CENTER for SCIENCE in PUBLIC PARTICIPATION

October 12, 2020

Scope of Review

This review was requested by Idaho Rivers United (IRU) for the purpose of providing geochemical information and analysis of the Stibnite Gold project. It includes an assessment of data validity and assumptions in geochemical models that affect water quality. Material reviewed all or in part included:

Figure 6. Tailings tested for acid and neutralization potential. Source: SRK 2017a, Table 3-61

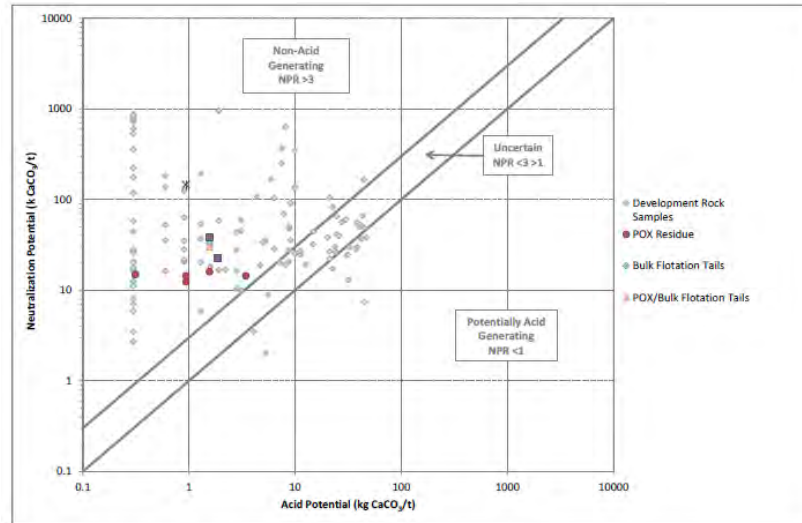
- Tailings leachate chemistry testing could be improved. Only SPLP tests were done due to a lack of material – why couldn't more material be made available? The MWMP has a liquid to solid ratio of 1:1 and is more representative of arid or semi-arid areas like the Stibnite site.

submitted for SPLP leach testing, rather than MWMP, due to the limited quantity of tailings material available for testing and the finer grain size. Some of the disadvantages of the SPLP test are the high liquid to solid ratio (3:1) that may result in an underestimate of leachability and grain size reduction may increase reactivity. The MWMP and HCT leachate chemistry for the tailings and development rock is therefore not directly comparable. The SPLP results only provide a qualitative evaluation of constituents that could occur at concentrations above the water quality criteria and are not considered to be conclusive or to represent actual predictions of water quality.⁶⁴

Figure 7. Waste rock and ore acid and neutralization potential. Green dots show waste rock material chosen for HCTs; the black dot is an ore sample chosen. No surface samples were chosen. *Source: SRK 2017 baseline Fig. 3-8*

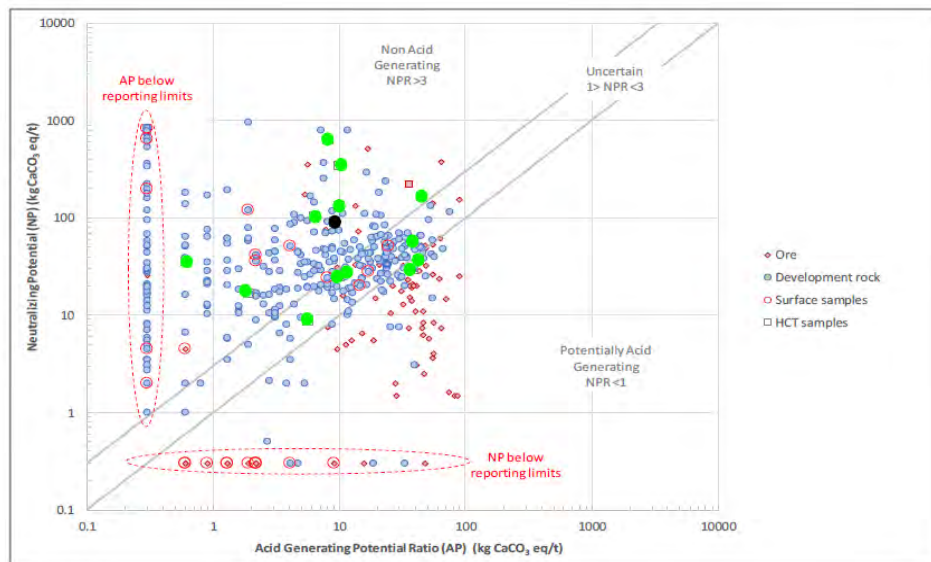
- Only a single sample of ore-grade material went through HCTs (Fig. 7). The ore-grade sample was chosen from non-acid generating material, when most ore-grade material falls in the potentially acid generating area. Including them in HCTs would provide information on the rates at which analytes may leach from this material, which will be present on pit walls, tunnels if underground mining occurs, and potentially in waste rock an tailings.
- No HCTs were conducted on legacy waste rock.⁷⁰

Figure 8. Model of future contaminant concentrations based on past precipitation. (Upper) Annual average precipitation data applied in predictive SWWC model. (Lower) Predicted future arsenic concentrations at HF WRF. Source: SRK 2018c Fig 4-9, Fig 4-17, and others.

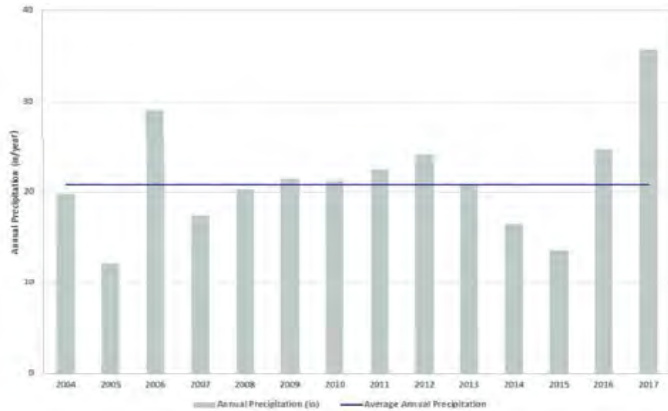
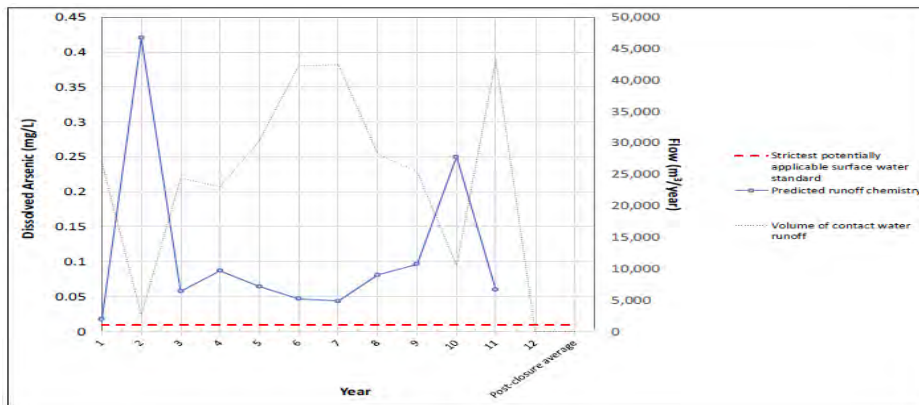
- Future climate was based on past climate. This will underestimate the extent and frequency of dry and wet periods.
- No waste rock management plan (WRMP). The DEIS relies on several assumptions made with respect to the WRMP, such as no blending of waste rock and the lithological composition of each WRF and the YP backfill.⁸³ The final location of waste rock from different pits is necessary to inform the geochemical model.

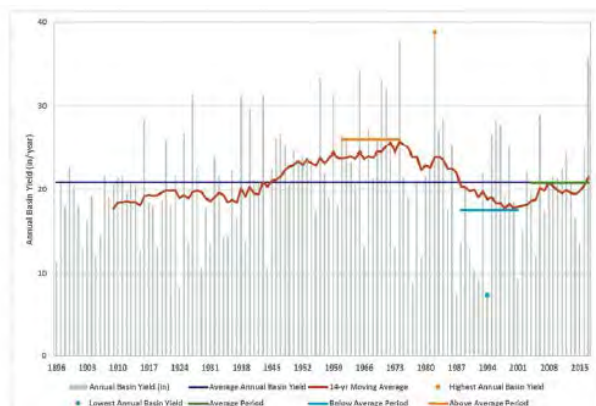
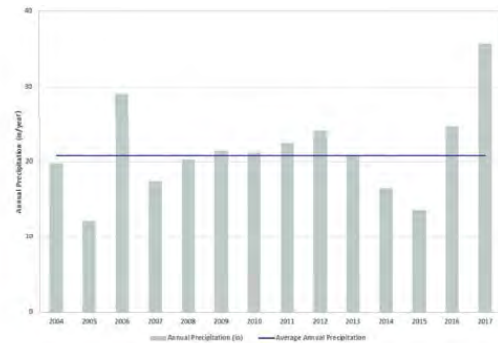
- A wider range of precipitation needs to be considered in bounding uncertainty (Fig. 10).
